January 30, 2009 Subject: DS 450 Xmx Tire Pressure Decal

No. **2009-5**

YEAR	MODEL NAME	MODEL NUMBER	SERIAL NUMBER
2009	DS 450 Xmx	3H9A	See attached List

Tire Pressure Decal

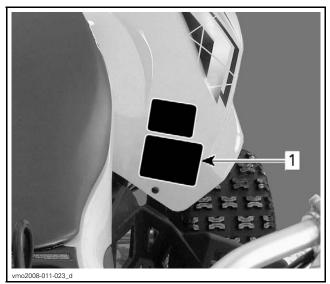
An incorrect tire pressure decal may have been installed on some units of the above mentioned model.

Update vehicles with a correct tire pressure decal. Correct tire pressure specification should be as per the following table.

TIRE PRESSURE		FRONT	REAR
Up to	MAXIMUM	69 kPa (10 PSI)	62 kPa (9 PSI)
(220 lb)	MINIMUM	55 kPa (8 PSI)	48 kPa (7 PSI)

- 1. Clean the entire original decal surface and dry thoroughly.
- 2. Carefully install the new decal over the original decal.
